# ACCELERATED DISTRIBUTION DEMONSTRATION SYSTEM

SUBJECT: Forwards addl info re response to reactor coolant pump tripping strategy issue,per NRC 880824 request.

Subject: Palo Verde Nuclear Generating Station (PVNGS)  
Units 1, 2 and 3  
Response to NRC Request for Additional Information - Reactor  
Coolant Pump Trip Strategy  
File: 88-A-056-026

**ATTACHMENT - ANPP RESPONSES TO NRC QUESTIONS**

**FIGURE 1  
SINGLE LINE  
DIAGRAM**

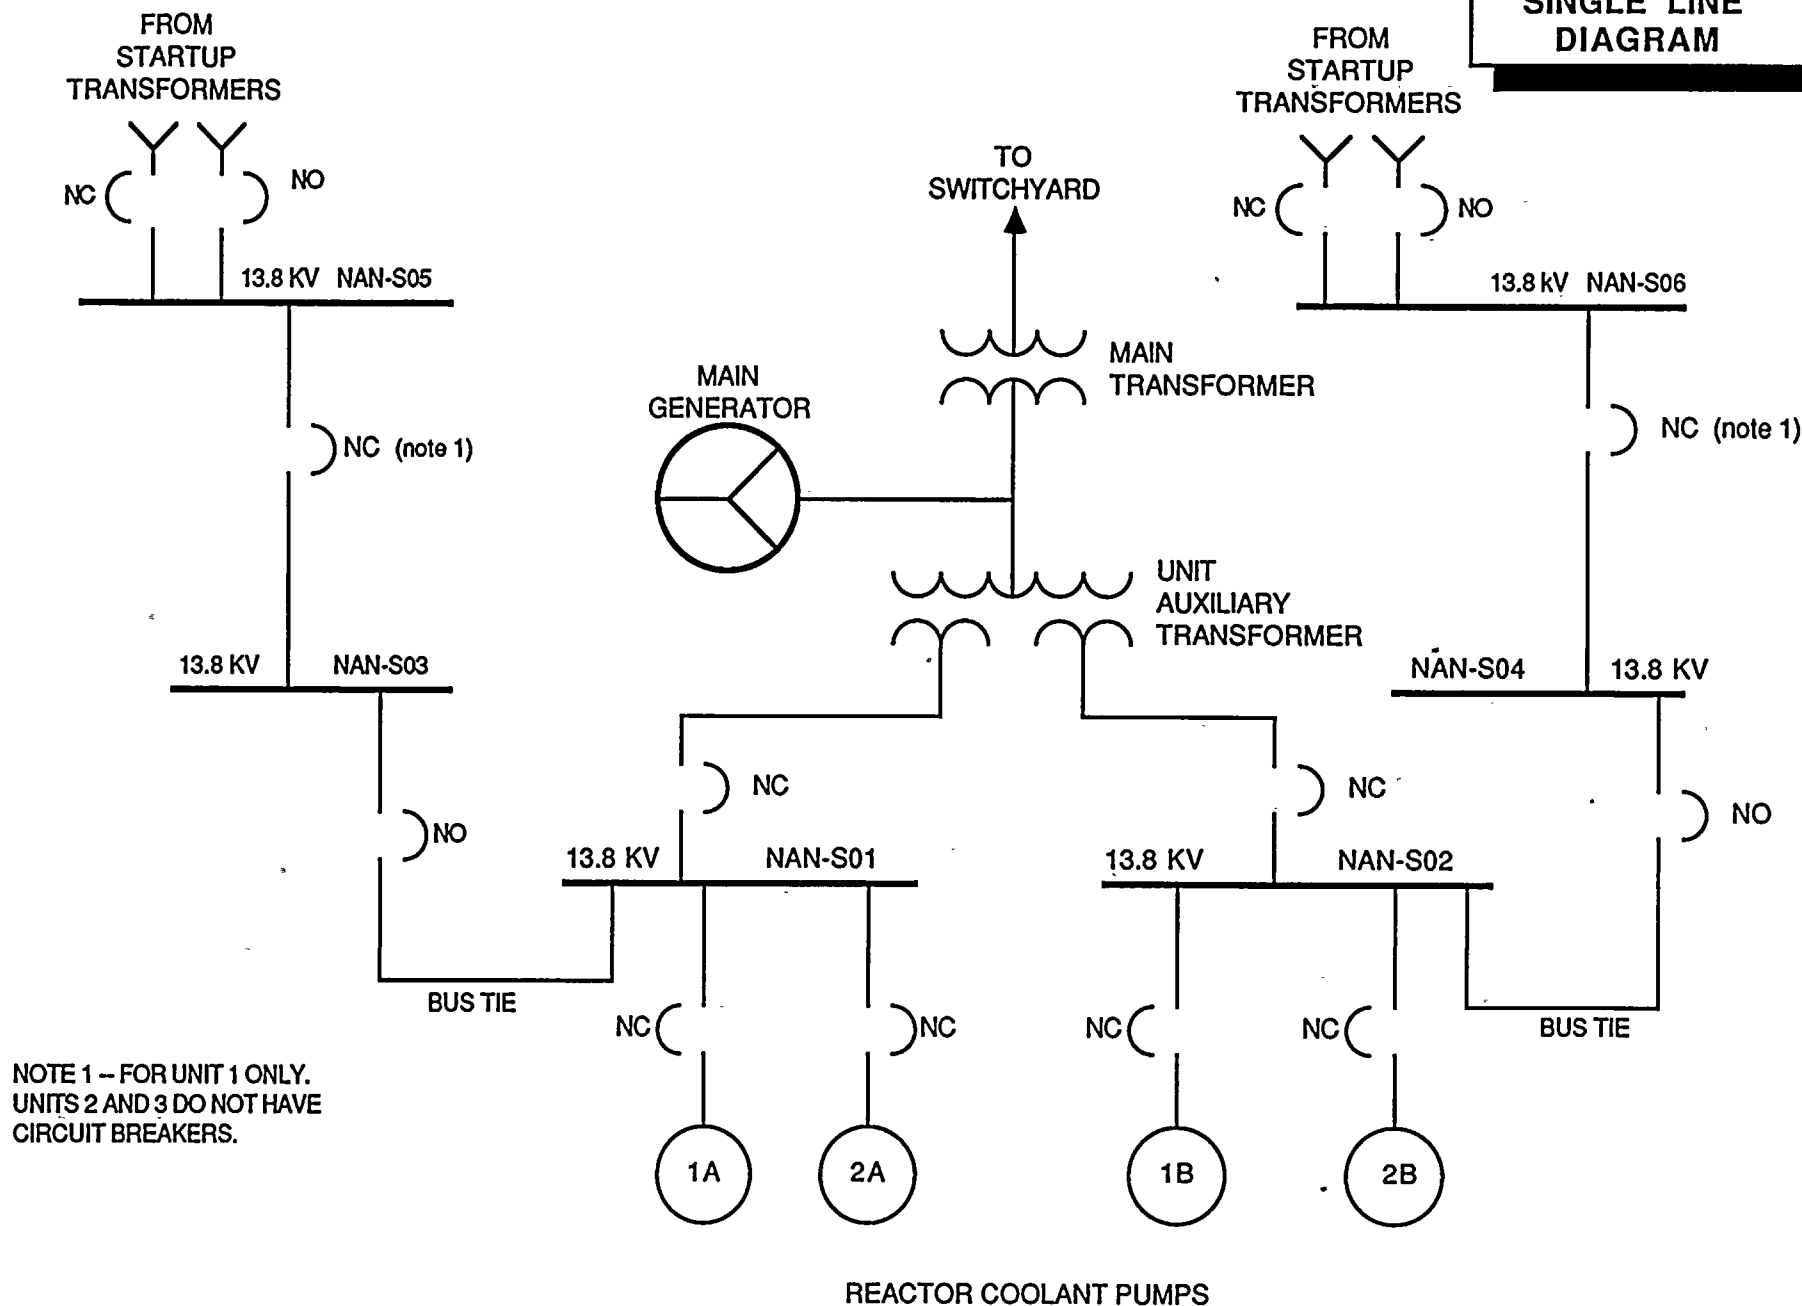
- a. Identify the components required to trip the pumps. Include relays, power supplies, breakers, or other equipment. Address equipment reliability, alternate trip methods, and operator training. How much time are the operators allowed to try and trip the RCPs from the control room before they use an alternate trip method? How much time is required to travel to an alternate trip location?
- b. If necessary, as the result of the location of any critical component, include the effects of adverse conditions inside or outside containment on RCP trip reliability. Describe the basis for the adverse conditions selected.

The four RCPs receive power from two separate non-Class 1E busses. RCPs 1A and 2A are fed from 13.8 kV bus NAN-S01 while RCPs 1B and 2B are fed from 13.8 kV bus NAN-S02. Figure 1 shows the power supply arrangement for the RCPs. The 13.8 kV switchgear NAN-S01 and NAN-S02 are physically located in the switchgear room at the plant southwest corner of the turbine building (i.e., the corner of the turbine building closest to the control building as shown in Figure 2). The switchgear room is located at the grade elevation. As described in the following paragraphs, the RCPs can be tripped locally at the breaker. The breakers for the RCPs are located in the switchgear room. The switchgear room is considered a mild environment that should be accessible at all times during accident situations. If necessary, an operator can be sent to the switchgear room to open the RCP circuit breakers. Due to the proximity of the switchgear room to the
